FORD CD4E

NEW "WAVE" PLATE ADDED TO FORWARD CLUTCH ASSEMBLY

99-05 Page 1 of 10

Figure 1
AUTOMATIC TRANSMISSION SERVICE GROUP

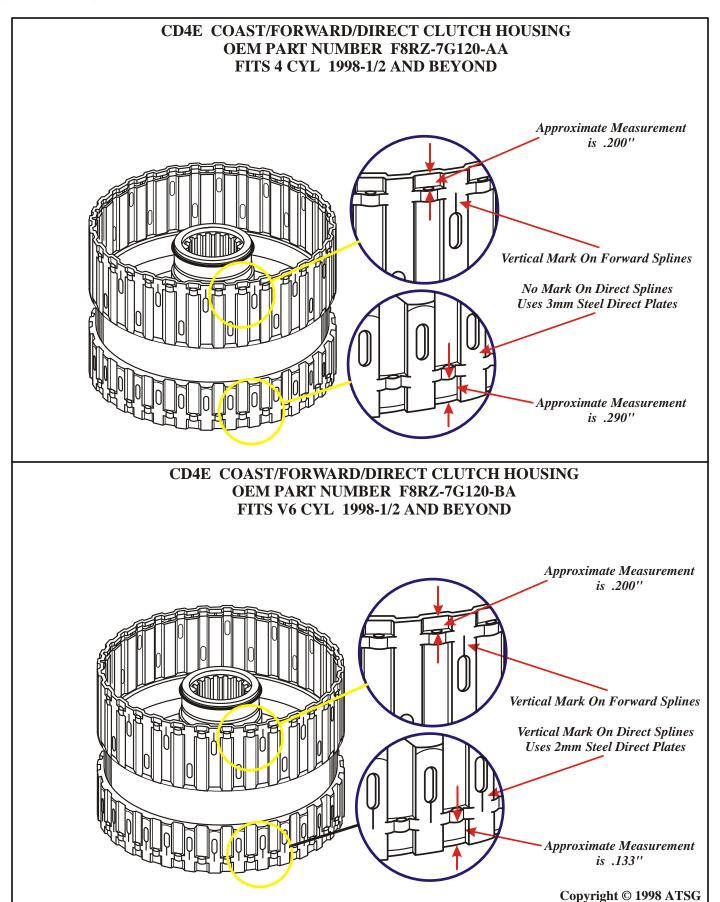
- (1) FORWARD/COAST/DIRECT CLUTCH HOUSING There is a new forward clutch snap ring groove location to help accommodate the addition of the wave plate. This has now created two new clutch housings, one for the 4 cylinder and one for the V6 cylinder, just for the 1998 1/2 models. Identification and approximate dimensions are provided on the new design level clutch housings in Figure 1.

Figure 4
AUTOMATIC TRANSMISSION SERVICE GROUP

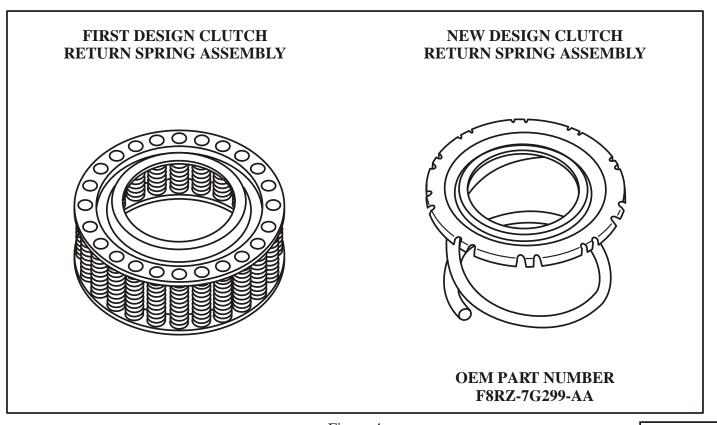
- (2) FORWARD CLUTCH RETURN SPRING Now has a single open coil design return spring instead of the previous multiple spring design as shown in Figure 4.

Figure 6
AUTOMATIC TRANSMISSION SERVICE GROUP

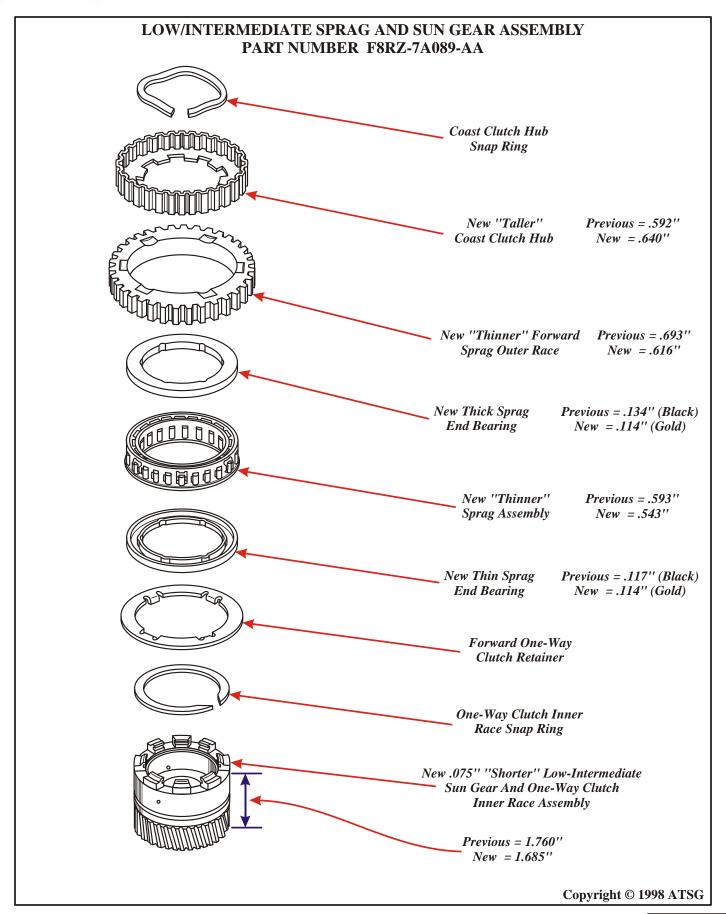
- (9) FORWARD ONE-WAY CLUTCH AND SUN GEAR ASSEMBLY The forward sprag and sun gear assembly is available only as a complete service package of all of the pieces shown in Figure 6 under OEM part number F8RZ-7A089-AA. However, many of the service package parts have revised dimensions that you need to be aware of and are as follows:
 - (A) Coast Clutch Hub Retaining Ring No changes. Refer to Figure 6.
 - **(B)** Coast Clutch Hub Has been made .053 taller to accommodate changes in the forward clutch pack, as shown in Figure 6.

(C) Forward Sprag Outer Race - Has been made .077 narrower to accommodate the changes in the forward clutch pack, as shown in Figure 6.

(D) *Thick End Bearing* - Has been made .020" thinner to accommodate the changes in the forward clutch pack, as shown in Figure 6. Both end bearings now the same.

(E) Forward Sprag Assembly - Has been made .050" narrower to accommodate the changes in the forward clutch pack, as shown in Figure 6.

(F) *Thin End Bearing* - Has been made .003" thinner to accommodate the changes in the forward clutch pack, as shown in Figure 6. Both end bearings now the same.

- (G) Forward Sprag Retainer No Changes. Refer to Figure 6.
- **(H)** *Forward Sprag Retaining Ring* No Changes. Refer to Figure 6.
- (J) Forward Sprag Inner Race And Sun Gear Assembly Has been made .075" shorter to accommodate the changes in the forward clutch pack, as shown in Figure 6.

Previous Design = .592".

New Design = .640".

Previous Design Cage = .693".

New Design Cage = .616".

Previous Design = .134" (Black in color)

New Design = .114" (Gold in color).

Previous Design = .593", Sprag Elements = .372".

New Design = .543", Sprag Elements = .307".

Previous Design = .117" (Black in color).

New Design = .114" (Gold in color).

Previous Design = 1.760".

New Design = 1.685".

Figure 8

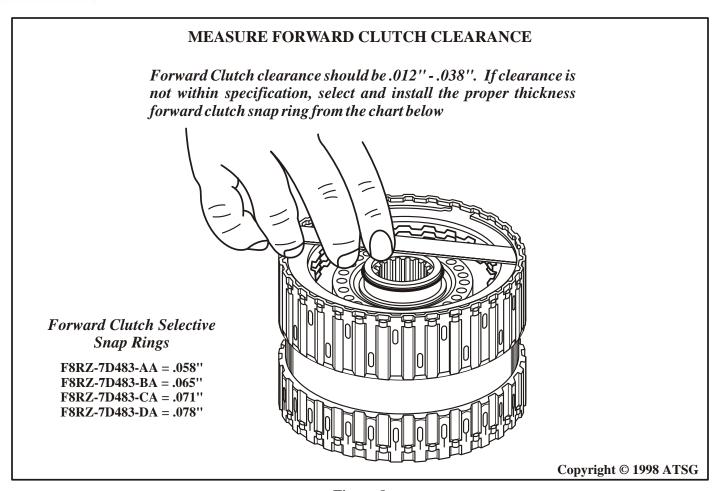
- (8) FORWARD CLUTCH SNAP RING Has always been selective to achieve the proper clutch clearance, but the above changes necessitated a new set of selective snap ring thickness to ensure the proper clutch clearance. Refer to Figure 8 for dimensions and part numbers.
